MERCURY MARINER

Service Bulletin

Bulletin No. 2010-01

Transom Bracket Replacement Kits

Heavy-duty transom bracket with added clearance

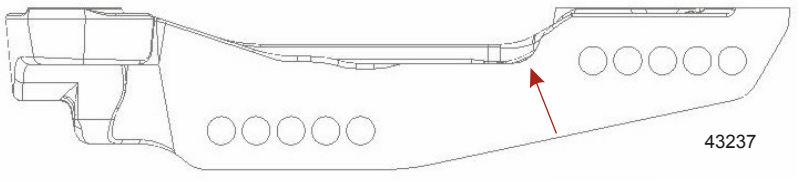
Some engines produced during model year 2001 and prior may have interference with the trim system when using the current replacement heavy-duty transom brackets.

The heavy-duty brackets in kit P/N 8M0045121 have additional clearance for the style trim systems used in model year 2001 and prior.

Because of the heavier design features of these transom brackets, it is required to replace both brackets as a set.
